Wolf Creek Dam Consensus Report Engineering Risk and Reliability Analysis

April 11, 2007

DSAC Class I Dams
Peer Review Panel

Peer Review – Dam Safety Action Classification (DSAC) Group1

Photo No. 3

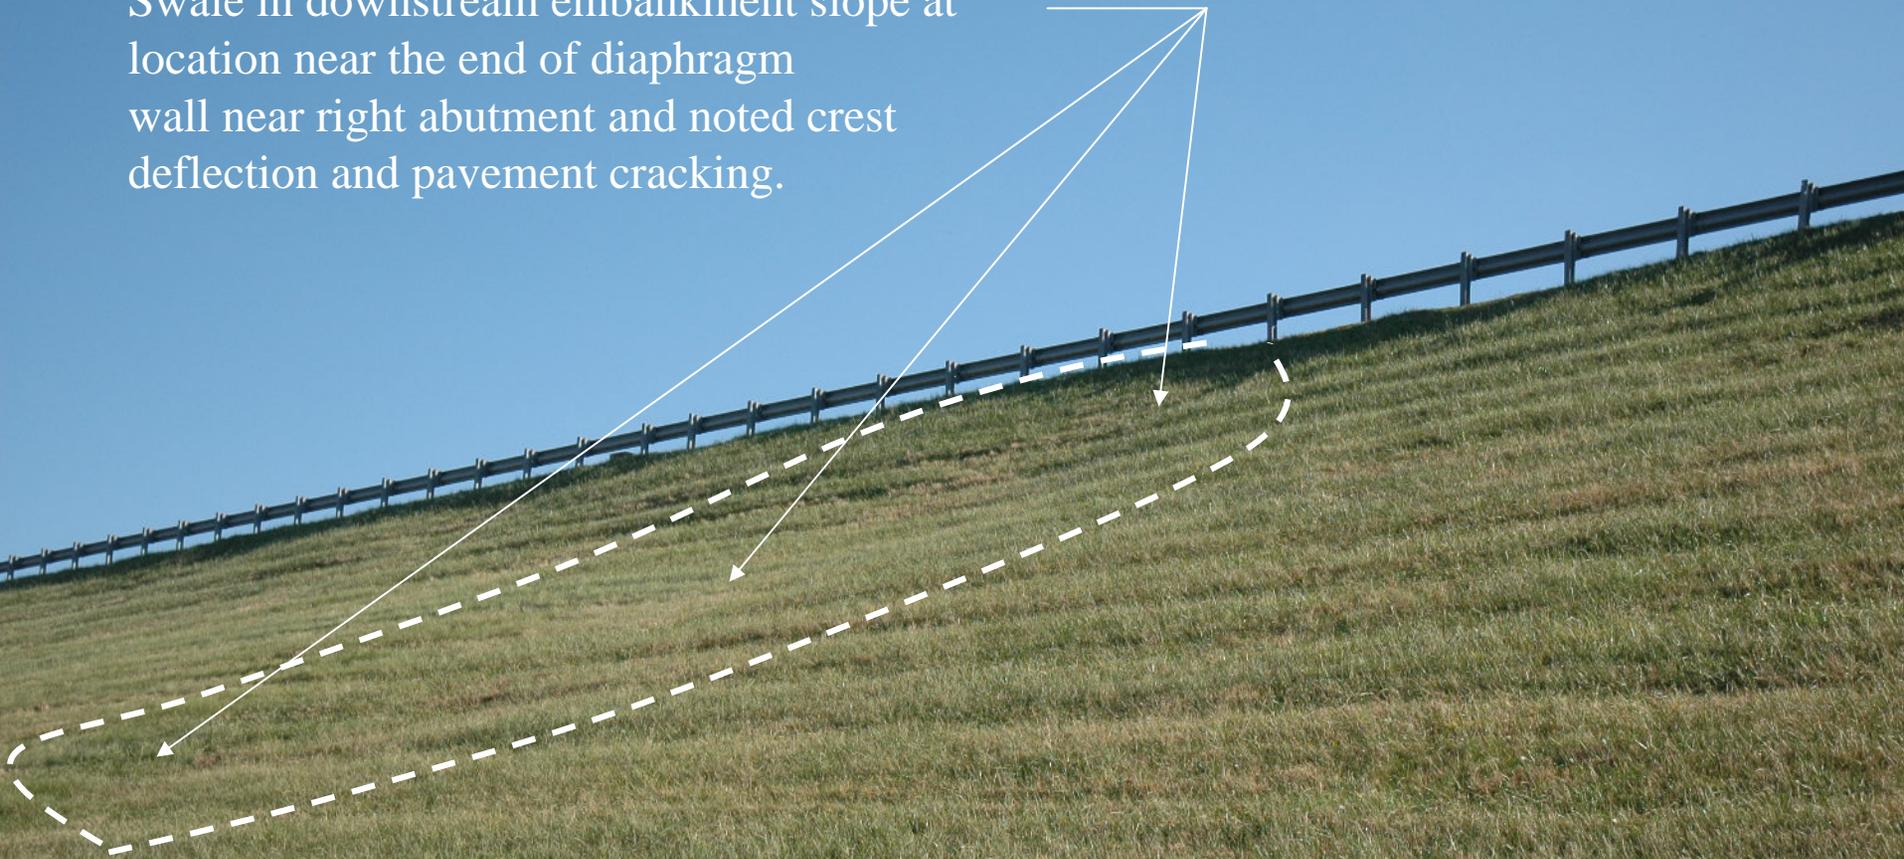
**Diaphragm wall cap at end
near right abutment. Note
minor cracking and separation
of concrete overlay from cap**

Photo No. 5
Overview of embankment
settlement area of concern
adjacent to Monolith 37

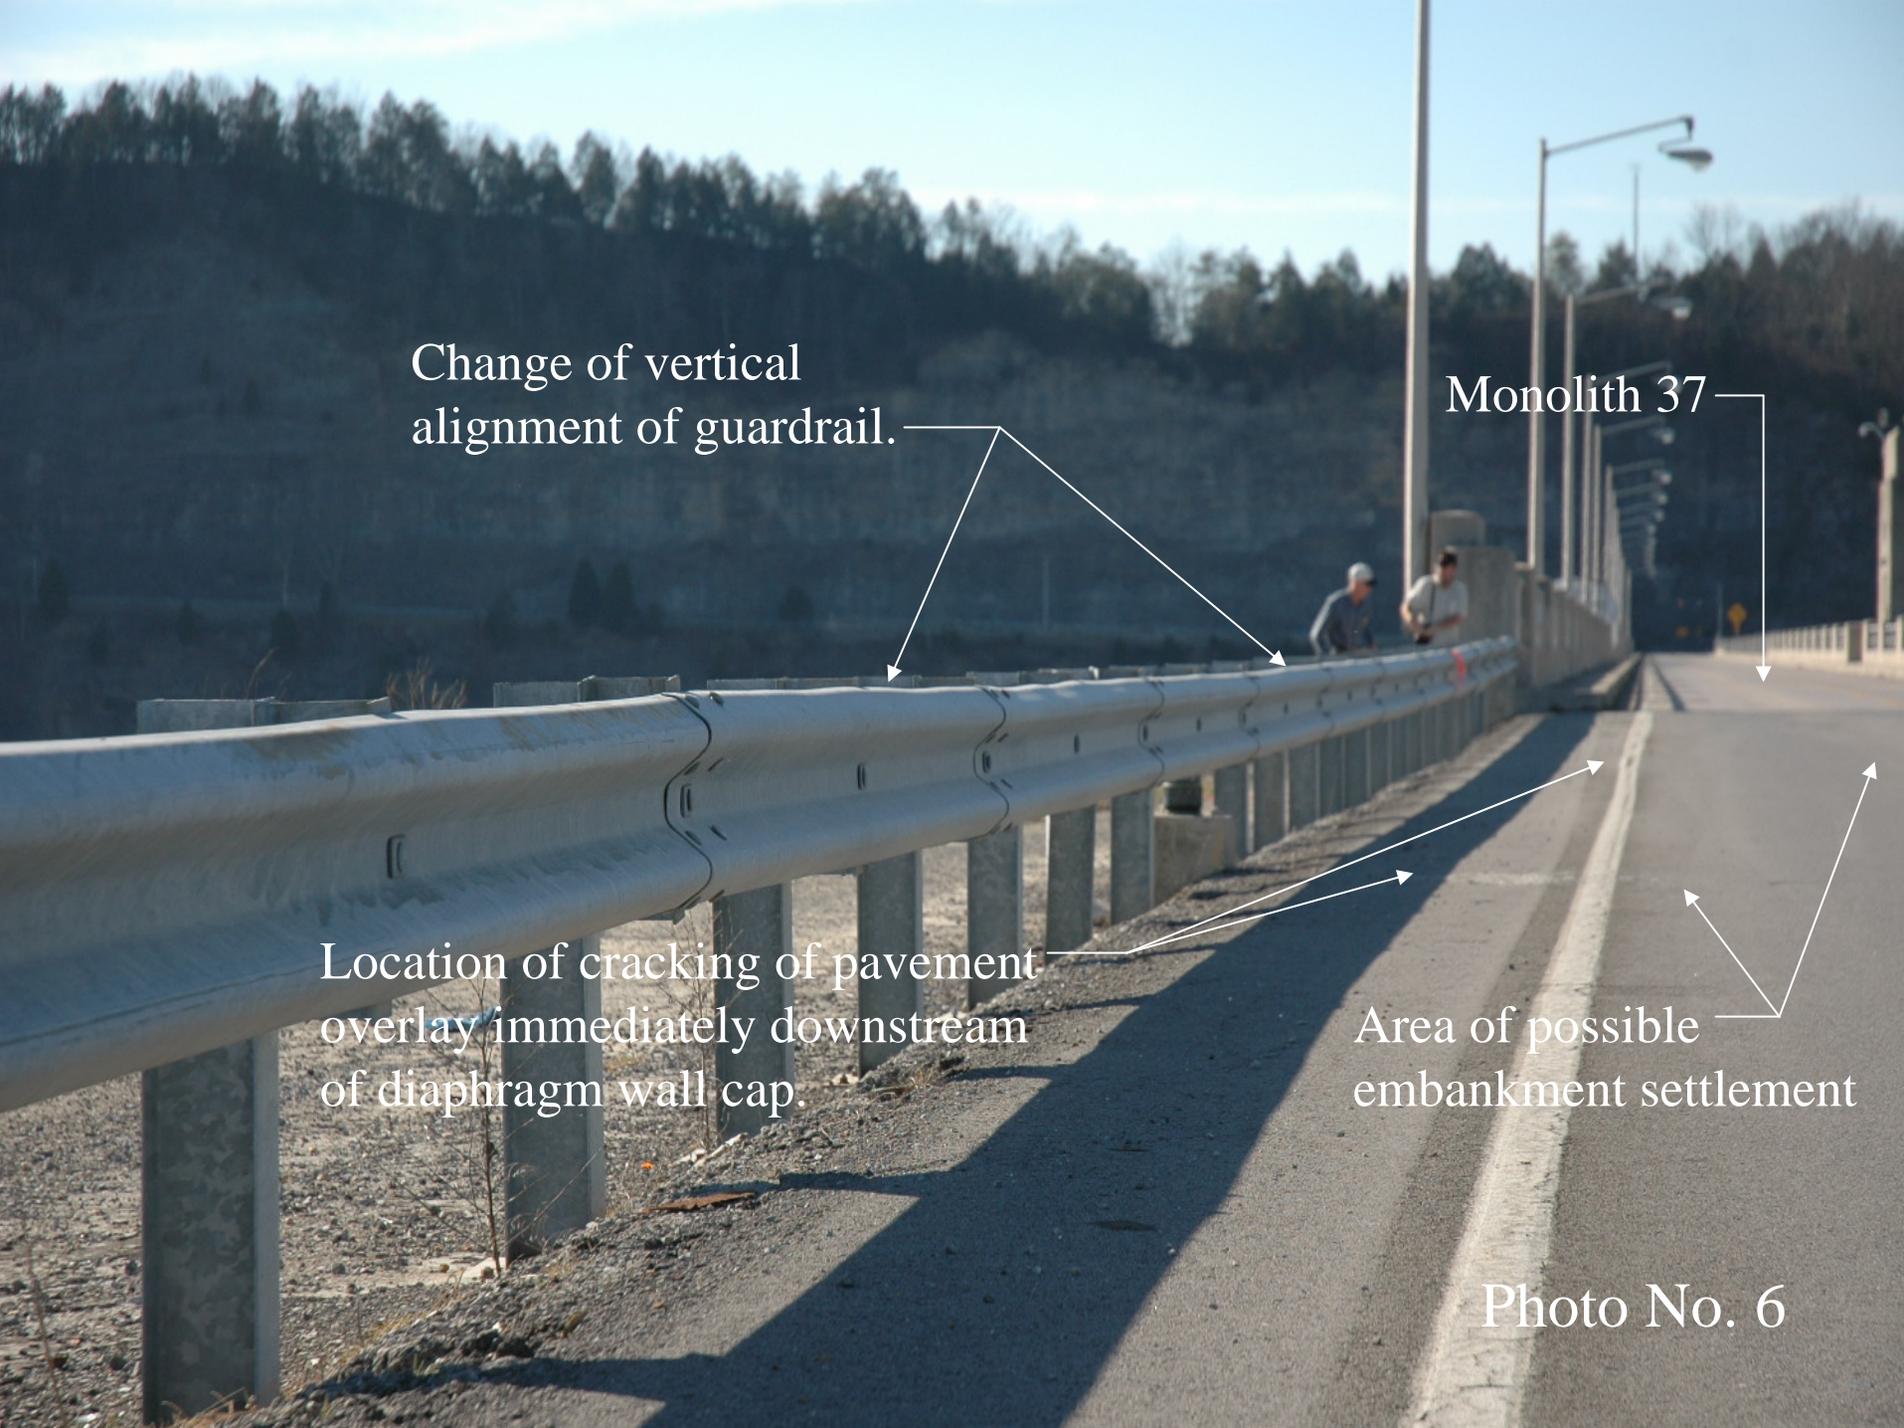
Change of vertical alignment of guardrail.

Photo No. 10

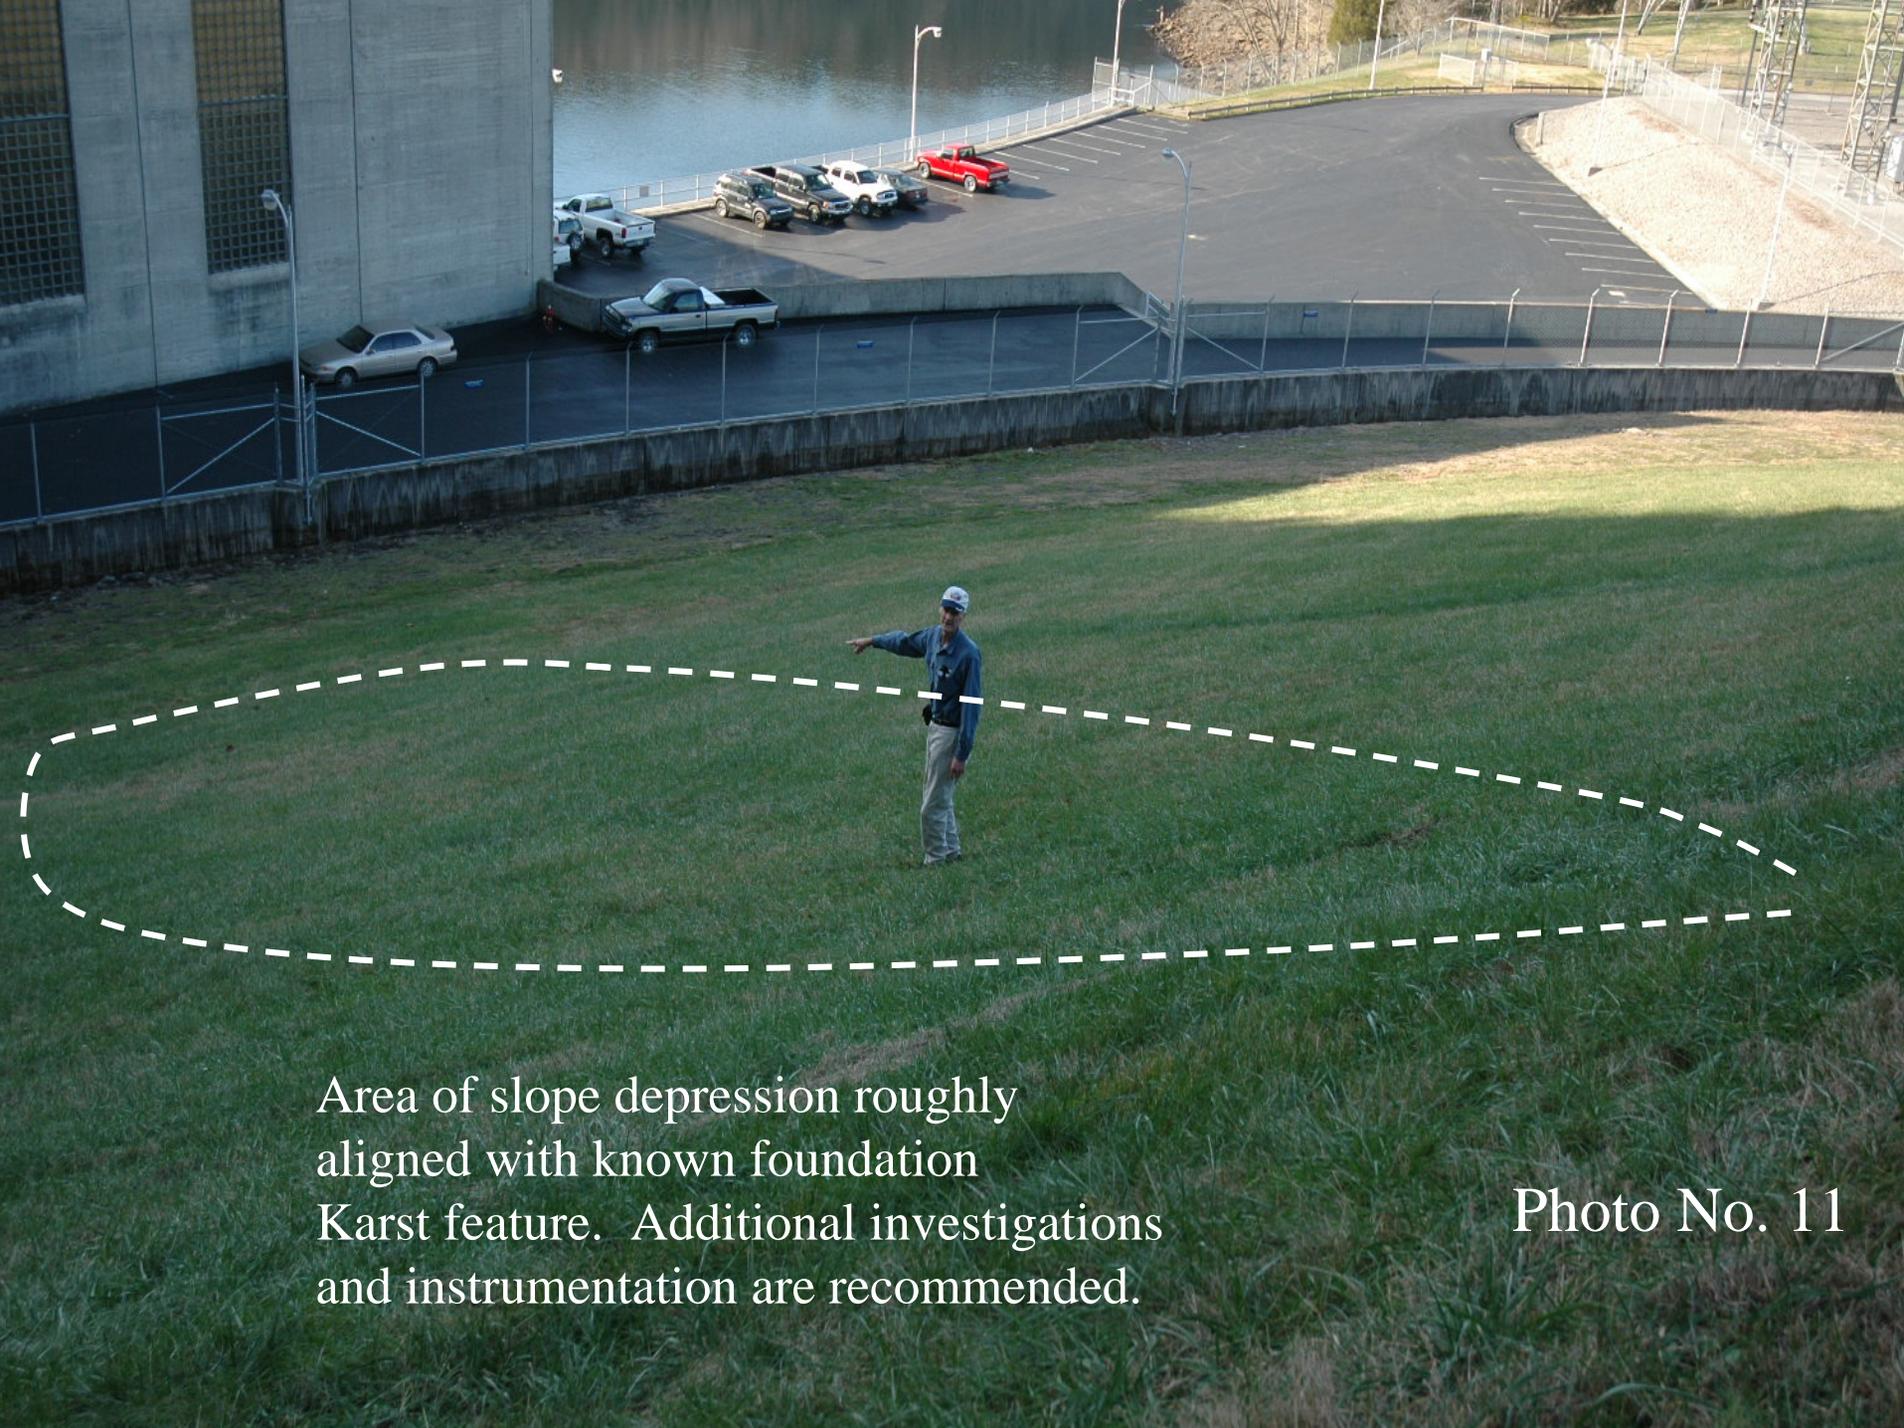
The Panel observed an opening (1/4 to 1/2 inch) along the upstream portion of the joint between Monoliths 36 and 37 (see Photograph 10) as well as evidence that the downstream portion of the same Monolith joints in compression (Photograph 9). These observations are consistent with the movement monitoring data for Monolith 37.

Upstream joint between
Monoliths 37 and 36.
Note opening of joint that
has occurred

Photo No. 13

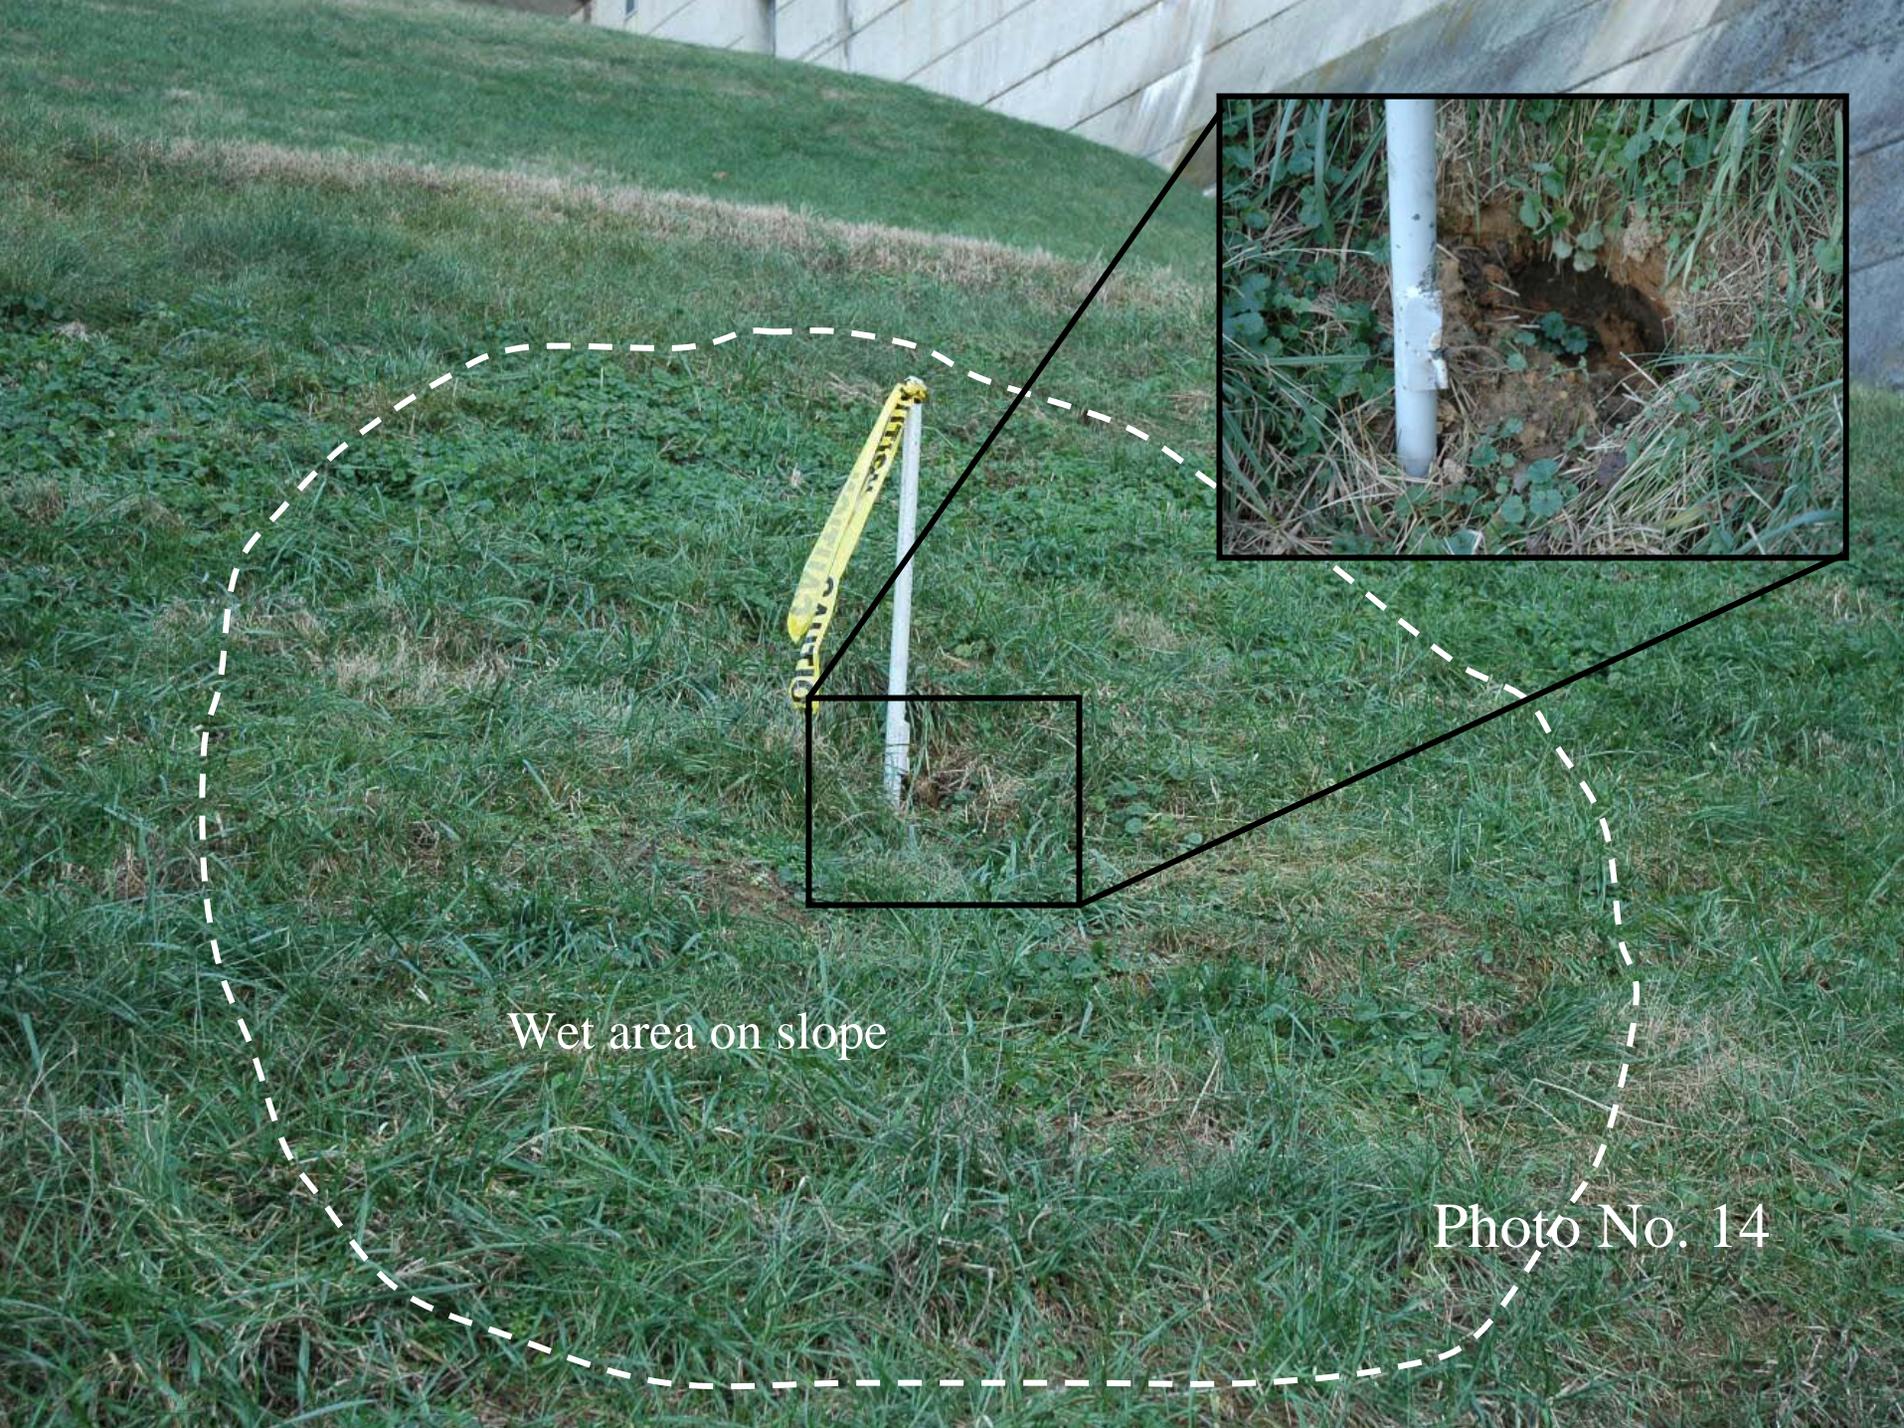
A small erosion feature (approximately 3-feet in diameter) has developed in the wrap around section near the contact between the embankment materials and the concrete toe about 1/5 the distance up the slope above the powerhouse (see Photograph 13). There is also evidence of settlement near the base of this slope at the entrance of the groin drain to the groin drain energy dissipater structure. District and operations personnel have determined that the hole is due to concentrated surface drainage in this area entering a ubiquitous system of shallow vole holes and washing out material that has to be cleaned out at the catch basin below. They have excavated this in the past and have “firmly established” this to be the case. It also appears possible that the contact joint between the slab and dam is not completely sealed with a flexible caulking compound and water flowing in the drain is capable of eroding the embankment materials immediately below the joint. The behavior of this area should continue to be monitored to verify that more serious problems are not developing.

Surface erosion feature having the appearance of a small sinkhole along the lower right groin between the concrete dam and wrap around section. Note additional depression from erosion near the groin energy dissipation structure.
